FIELD CHANGE ORDER

NUMBER: DS-650Q4-F001

MIRA MicroVAX 3000 (also called MIRA 3200) shipped before 03-JUL-1989. with the following part numbers require this FCO.

Quick Check: (Continued from Page 1)

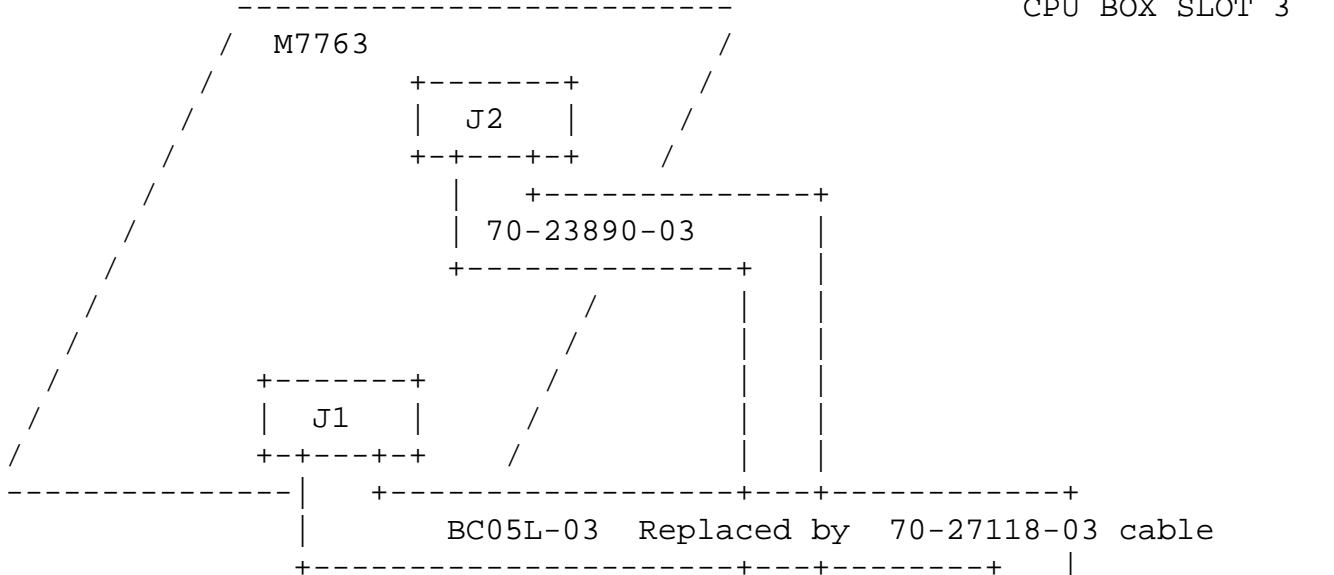
If all the cables on the watch-dog module M7763-00 are flat cables, this FCO is required.

If you find a round cable (70-27118-03) connected to the M7763, the module is at the correct Rev. (E), and the FCO is not required.

NOTE: This can be checked in both Systems A or B, as they must be identical in terms of revision levels of M7763.

SWITCHING  
BOX A  
SLOT 1

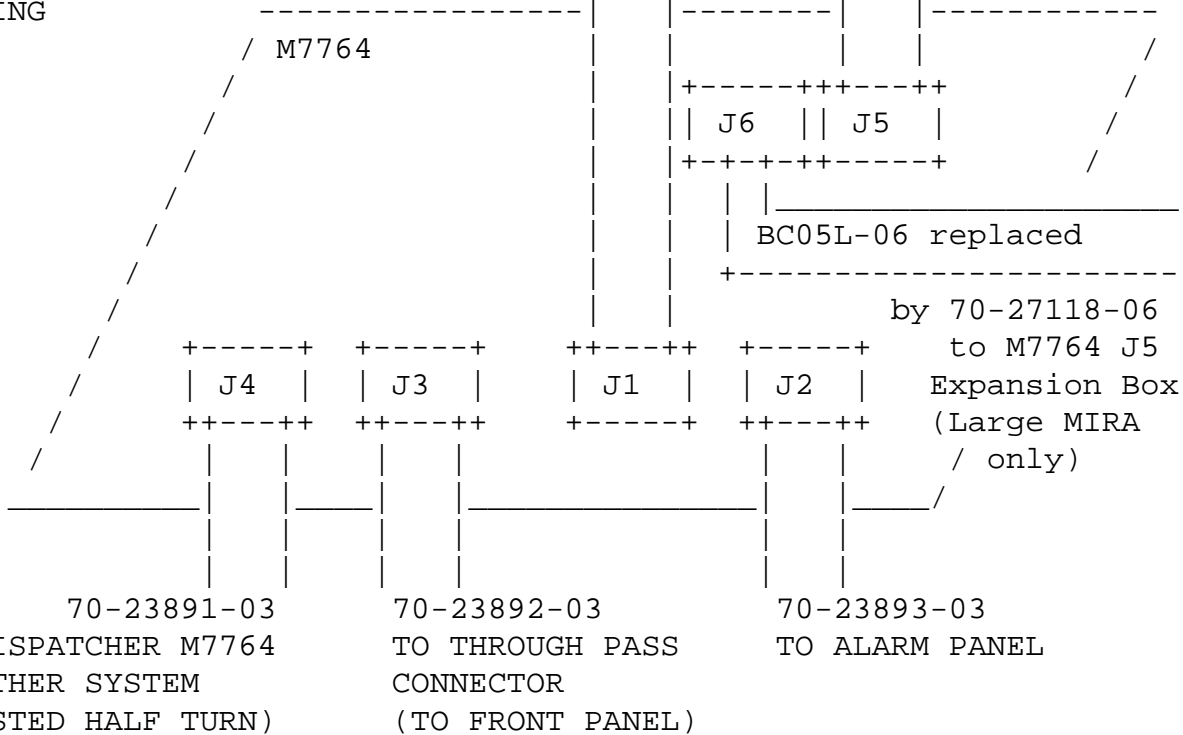
WATCH DOG MODULE TO BE REPLACED

COMPUTER A  
CPU BOX SLOT 3

DISPATCHER MODULE TO BE REPLACED

Replace all modules M7763 and M7764 at Revision D or below by new modules at Rev. E and replace BC05L dispatcher cables at one time.
